CHANDIGARH
HOUSING
BOARD

O.R.T. (SMALL FLATS) FOR SLUM DWELLERS
UNDER REHABILITATION PROGRAMME
DHANAS MALOY II, MAULIJAGRAN
TYPICAL FLOOR PLAN
CHANDIGARH (U.T.)

Civil Engineer.			
Structure Engineer.			
REVISIONS			
	S.NO.	DESCRIPTION	SIGN. DATE
Chief Architect.			Senior Architect.
Elect. Engineer.			Asstt. Architect.
Superintending Engineer CHB.			CHB.
Fire Fighting.	SCALE: (R. Sandhu) DRAWN BY: <i>Rajesh</i> (Shashi Thakur) PLACING ASSTT. <i>Shashi</i>	DATE: 23-02-2015	60 JOB NO.
			20 ORG. NO.
Ph. Engineer.	STANDARD DESIGN OF NEEDBASE CHANGE FOR L. I. G. HOUSES AT DHANAS, CHANDIGARH.

TYPICAL FLOOR PLAN

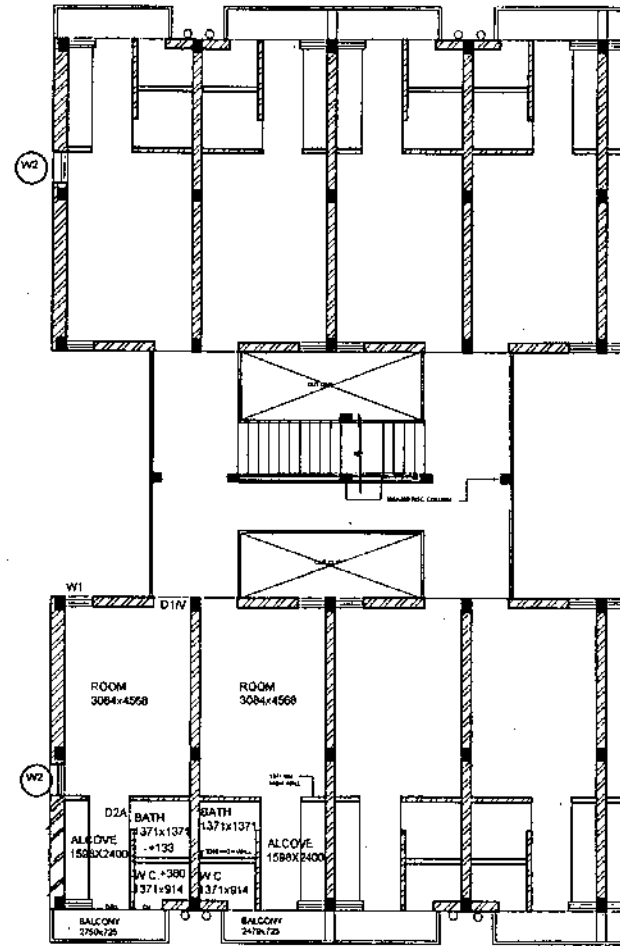
1. THE PROPOSAL OF ADDITIONAL WINDOW OF 760 MM. (2'-8") WIDTH HAVING CILL LVL. 685 MM. (2'-3") IN END WALL WITH LINTEL LVL SAME AS OTHER WINDOWS OF D.U. ALLOWED UNDER CLAUSE A7 OF NEED BASED CHANGES 7-7-2015 IS MARKED ON THE DRGS. BASED ON APPROVED DRG. NO. 21R2, JOB NO. 175.
2. FOR ANY OTHER DETAIL / NOTES REF. DRG. NO. 21R2, JOB NO .175.
3. IF REQUIRED BY THE ALLOTTEE TO ADD ANY ADDITIONAL WINDOW IN THE END WALL OF D.U. AS PER CLAUSE A7 THEN IT SHOULD BE ADDED AT THE LOCATION SHOWN AT W2
4. THE LOCATION, SIZE, CILL LVL. & LINTEL LVL. OF WINDOW SHOWN IN END WALL OF CORNER UNIT IS APPLICABLE OF ALL D.U. I.E. G.F. AND UPPER FLOORS SO THAT THE WINDOWS OF ALL FLOORS ARE VISIBLE IN SAME LINE IN ELEVATION.

TYPICAL FLOOR PLAN

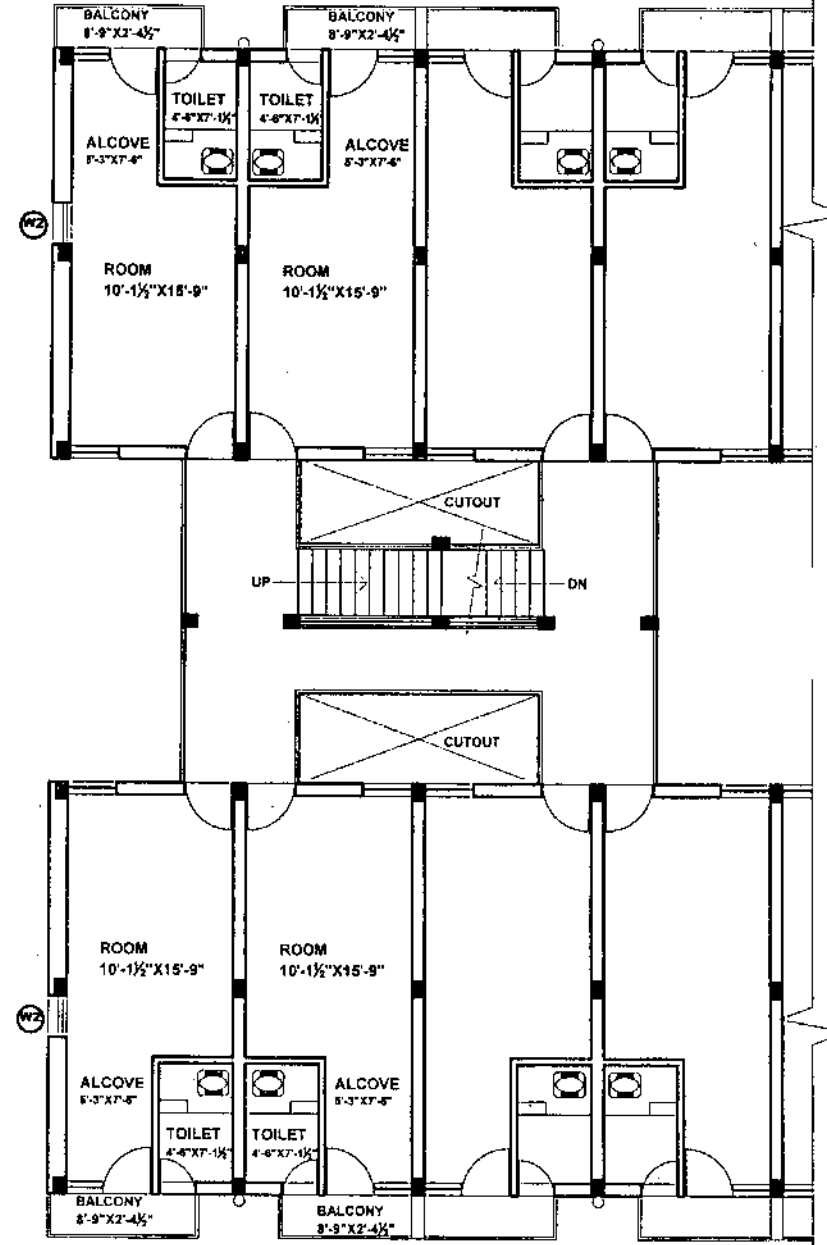
1. THE PROPOSAL OF ADDITIONAL WINDOW OF 760 MM.(2'-6") WIDTH HAVING CILL LVL. 685 MM. (2'-3"), IN END WALL WITH LINTEL LVL SAME AS OTHER WINDOWS OF D.U. ALLOWED UNDER CLAUSE A7 OF NEED BASED CHANGES 7-7-2015 IS MARKED ON THE DRGS. BASED ON APPROVED DRG. NO. 13R1 JOB NO. 175.
2. FOR ANY OTHER DETAIL / NOTES REF. DRG. NO. 13R1 JOB NO. 175.
3. IF REQUIRED BY THE ALLOTTEE TO ADD ANY ADDITIONAL WINDOW IN THE END WALL OF D.U. AS PER CLAUSE A7 THEN IT SHOULD BE ADDED AT THE LOCATION SHOWN AT W2.
4. THE LOCATION, SIZE, CILL LVL. & LINTEL LVL. OF WINDOW SHOWN IN END WALL OF CORNER UNIT IS APPLICABLE OF ALL D.U. I.E. G.F. AND UPPER FLOORS SO THAT THE WINDOWS OF ALL FLOORS ARE VISIBLE IN SAME LINE IN ELEVATION.

GROUND FLOOR PLAN

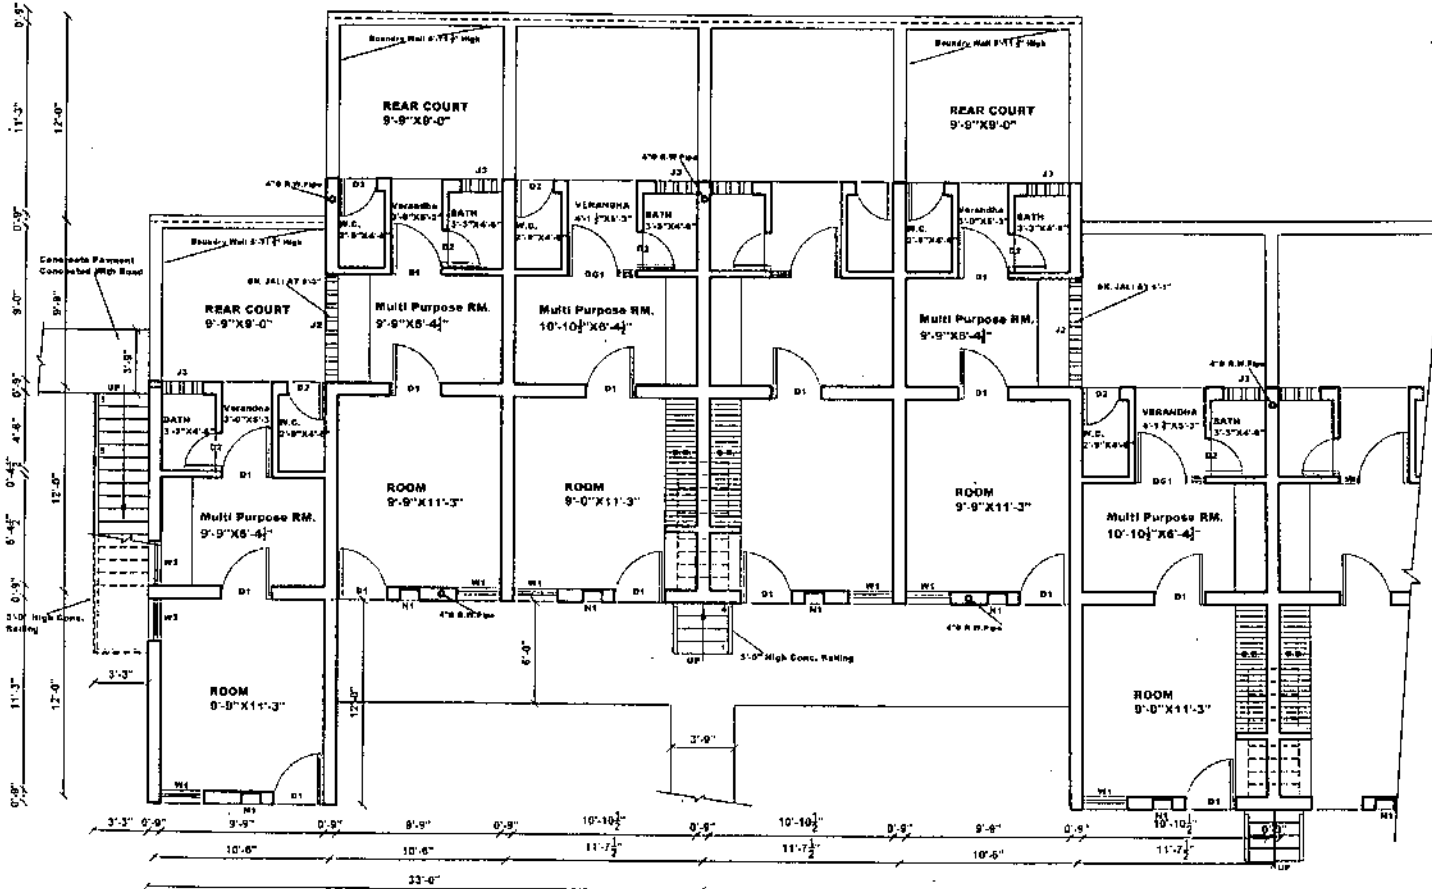
NOTE:-
 1. THIS DRAWING IS ONLY FOR THE PURPOSE OF CONSTRUCTION OF ROOM / TOILET / STORE ALLOWED UNDER NEEDBASE CHANGES 23-03-2010.
 2. THE PROPOSAL OF ADDITIONAL CONSTRUCTION UNDER CLAUSE A3 AND CLAUSE 15 (II) OF NEED BASED CHANGES 23-3-2010 IS MARKED ON THE DRGS. BASED ON APPROVED DRG. NO. 7, JOB NO. 80
 3. FOR ANY OTHER DETAIL / NOTES REF. DRG. NO. 7, JOB NO. 80.

FIRST FLOOR PLAN

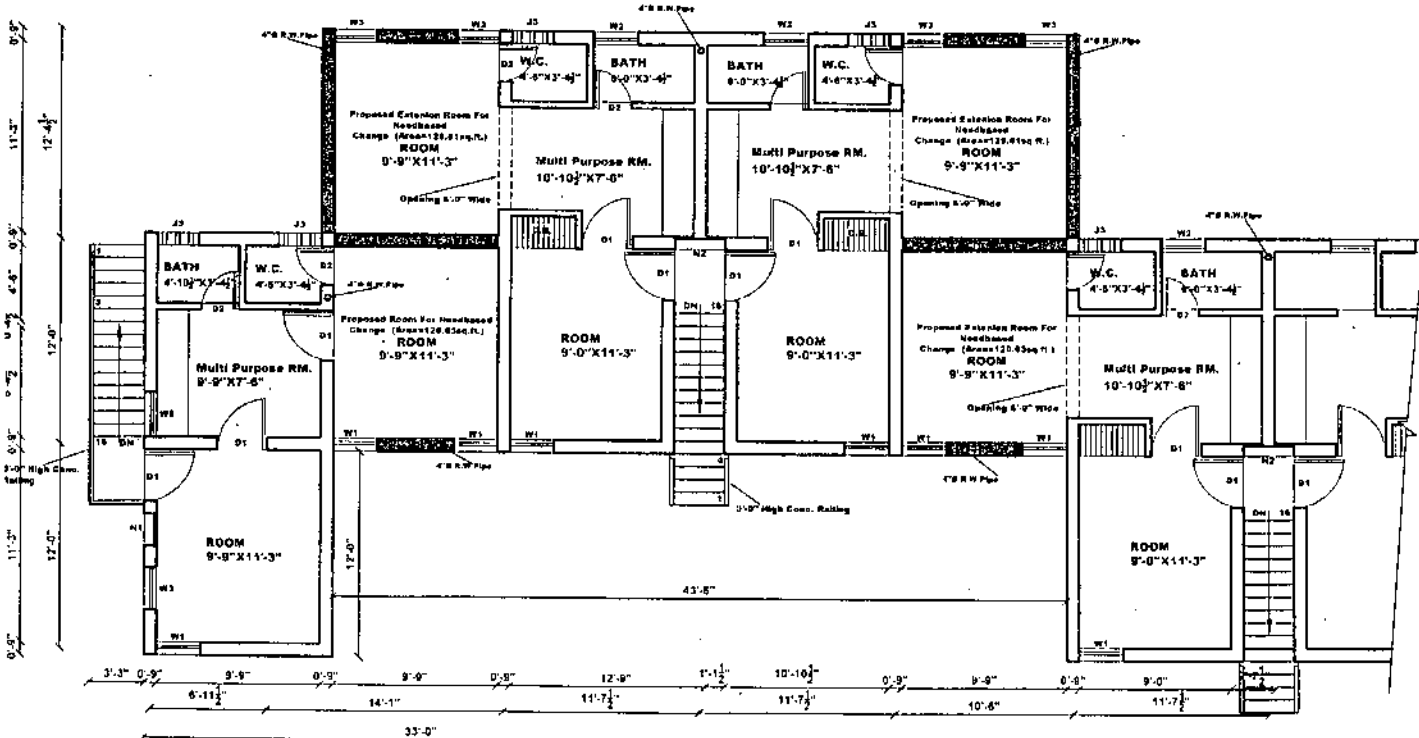
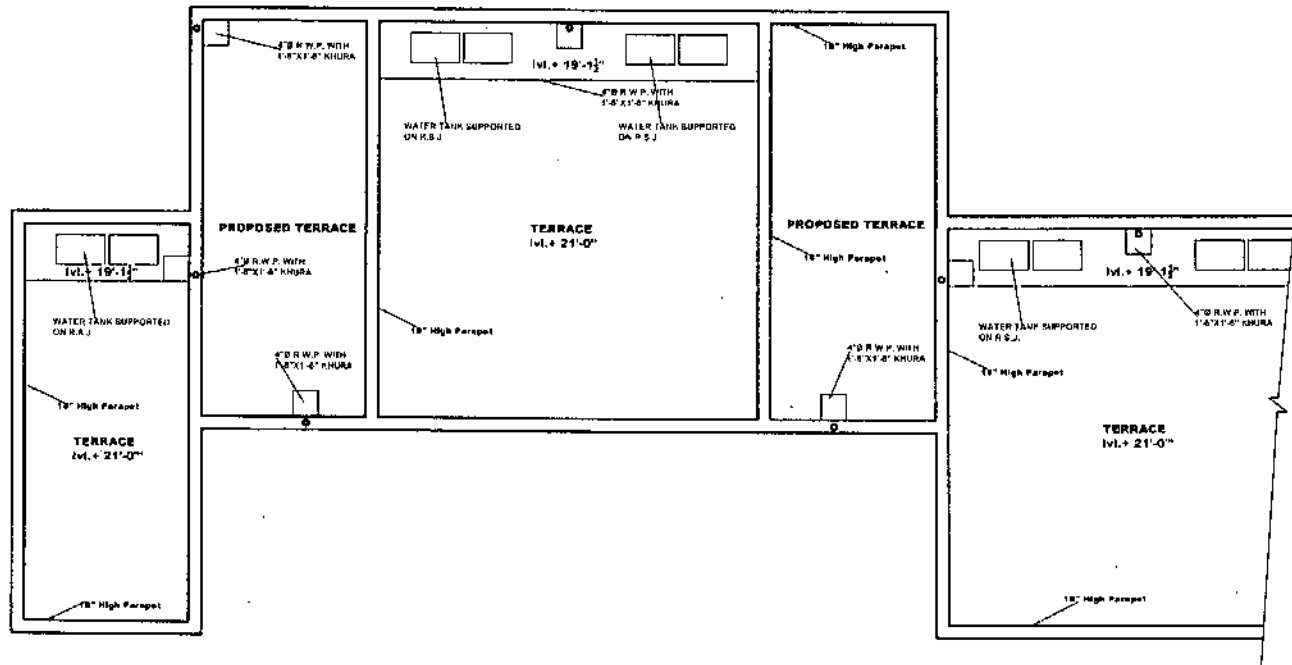
NOTE:-
 1. THIS DRAWING IS ONLY FOR THE PURPOSE OF CONSTRUCTION OF ROOM / TOILET / STORE ALLOWED UNDER NEEDBASE CHANGES 23-03-2010.
 2. THE PROPOSAL OF ADDITIONAL CONSTRUCTION UNDER CLAUSE A3 AND CLAUSE 15. (ii) OF NEED BASED CHANGES 23-3-2010 IS MARKED ON THE DRGS. BASED ON APPROVED DRG. NO. 7, JOB NO. 60
 3. FOR ANY OTHER DETAIL / NOTES REF. DRG. NO. 7, JOB NO. 60.

TERRACE FLOOR PLAN

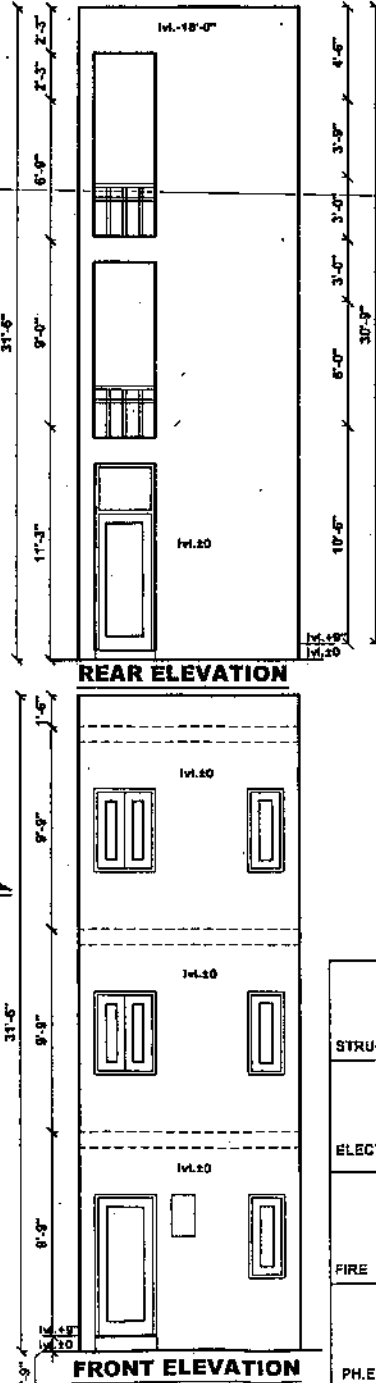
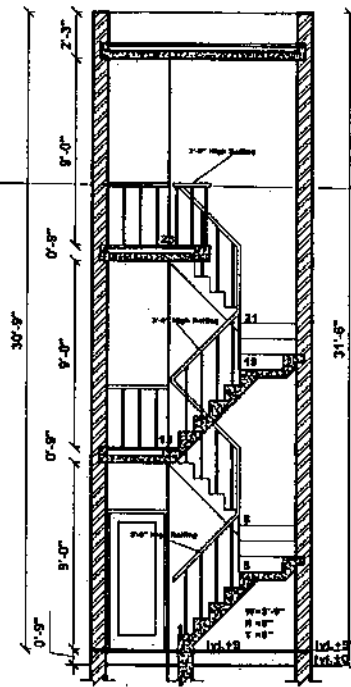
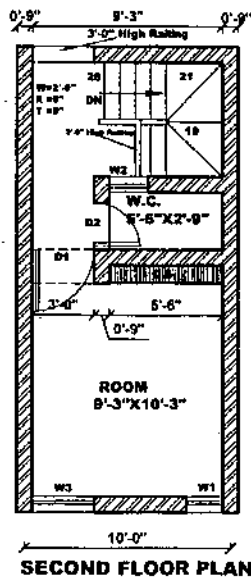
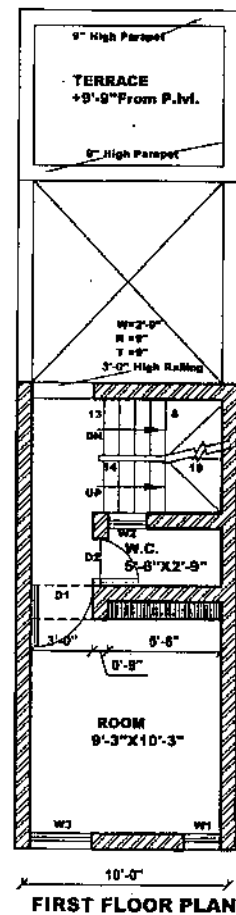
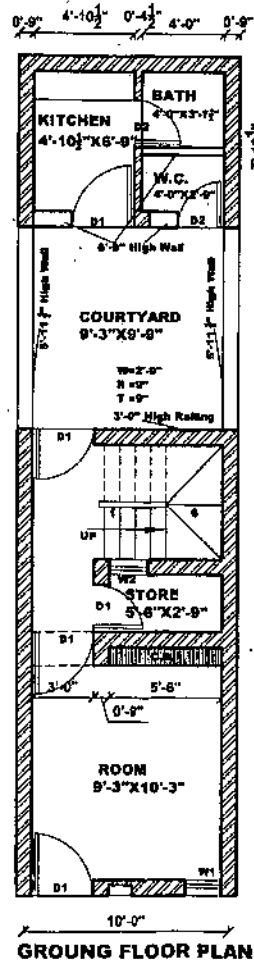
1. THIS DRAWING IS ONLY FOR THE PURPOSE OF CONSTRUCTION OF ROOM / TOILET / STORE ALLOWED UNDER NEEDBASE CHANGES 23-03-2010.
2. THE PROPOSAL OF ADDITIONAL CONSTRUCTION UNDER CLAUSE A3 AND CLAUSE 15 (ii) OF NEED BASED CHANGES 23-3-2010 IS MARKED ON THE DRGS. BASED ON APPROVED DRG. NO. 8, JOB NO. 60
3. FOR ANY OTHER DETAIL / NOTES REF. DRG. NO. 8, JOB NO. 60.
